VOLKSWAGEN DEALER COMMUNICATION

Repair Available – Safety Recall Code 42J5 / Rear Axle Coil Springs

42J5 Coil Spring Part Tag Guide

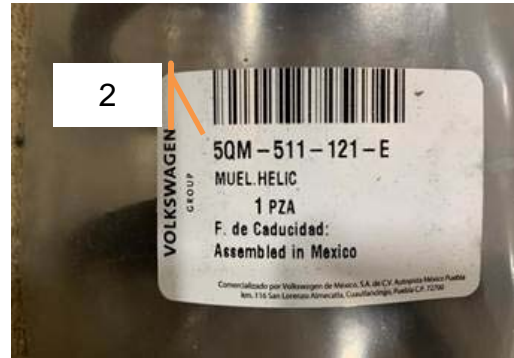
Several part numbers used in Safety Recall 42J5 were consolidated under one (1) part number. Before filing a factory mis-box claim, and to help avoid repair delays, please refer to the table below to identify an acceptable coil spring part tag.

Coil spring tag (1) does not match the packaging label (2).

This is **OK**.

Ordering Part Number	OK (Acceptable) Tag Part Number		
5QM-511-121-D	5QM-511-121-D	5Q0-511-121-AE	5QD-511-121-D
5QM-511-121-E	5QM-511-121-E	5Q0-511-121-AF
